To: T10 Technical Committee
From: Rob Elliott, HP (elliott@hp.com)
Date: 9 October 2002
Subject: T10/02-404r0 SAM-3 Data In Size and Sense Data Size for Execute Command

Figure xx. Application client buffers

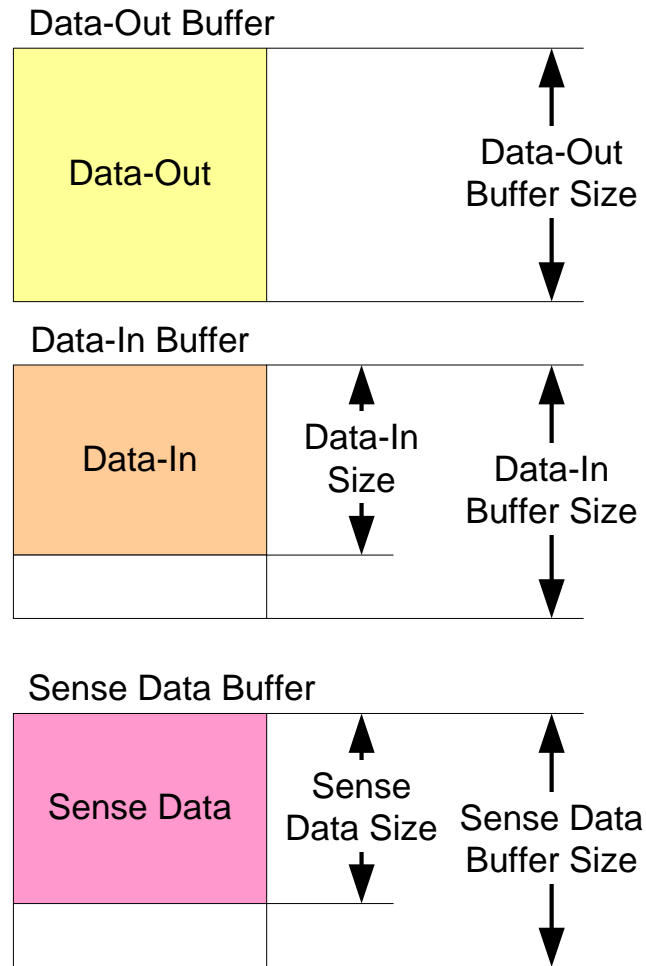
Figure xx shows the Data-Out Buffer, Data-In Buffer, and Sense Data Buffer provided by the application client for the lifetime of the command. The buffers shall not overlap.
